EAGLE TECHNICAL BULLETIN

Eagle Service Bulletin Number: **TB-E407-789-15**

Purpose: To allow the optional start switch upgrade.

This Technical Bulletin provides installation information for the 407HP installation as it applies to Bell 407 aircraft with Aeronautical Accessories Inc. Pulse Light Kit installed per STC SR09239RC.

FIGURE 1: START SWITCH UPGRADE COMPONENTS INSTALLATION

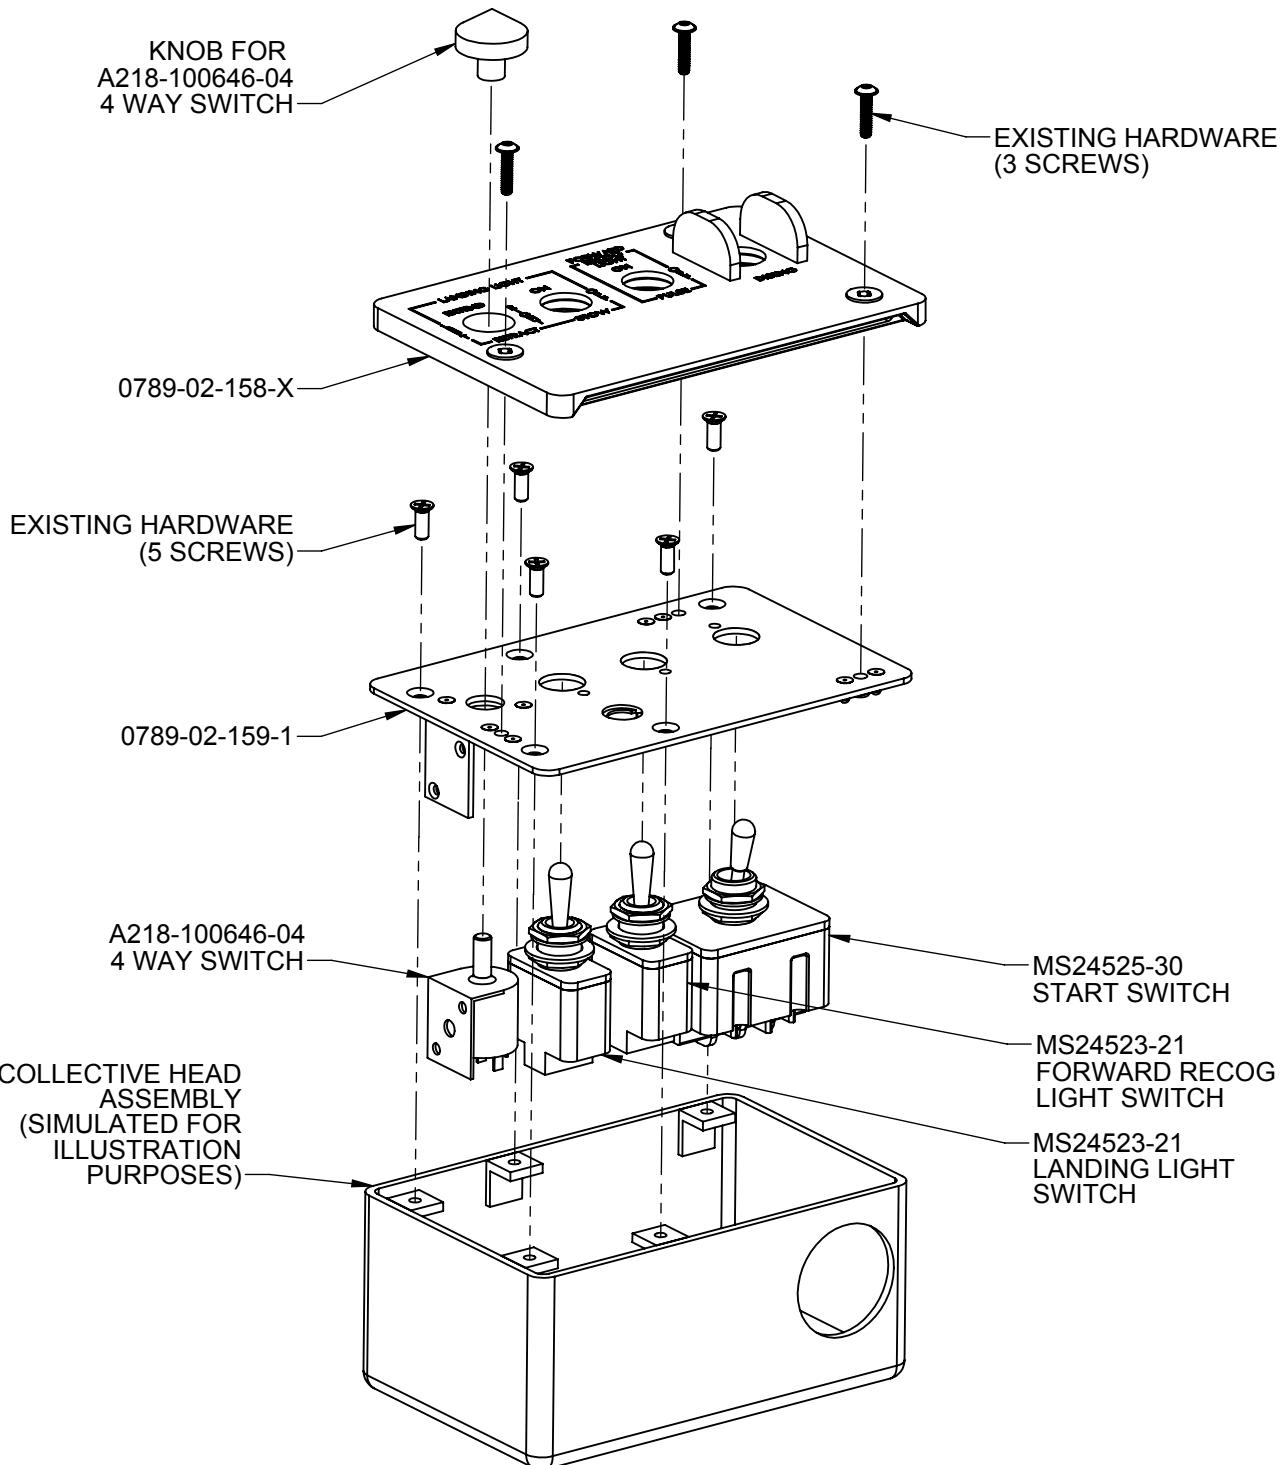
3. Disconnect electrical connections from the Start Switch and remove the switch.
4. Install the previously removed (in step 2) 4 Way Switch, Landing Light Switch and Forward Recog Light Switch on the 0789-02-159-1 Switch Plate Assembly per Figure 1.

5. Install P/N MS24525-30 Start Switch on the 0789-02-159-1 Switch Plate Assembly per Figure 1.
6. Connect wiring to Start Switch per IIN-E407-789 and wiring diagram 0789-14-001.

7. Install 0789-02-159-1 Switch Plate Assembly with Switches installed on the collective head using existing hardware per Figure 1.
8. Install 0789-02-158-X Panel Assembly on the collective head using existing hardware per Figure 1.
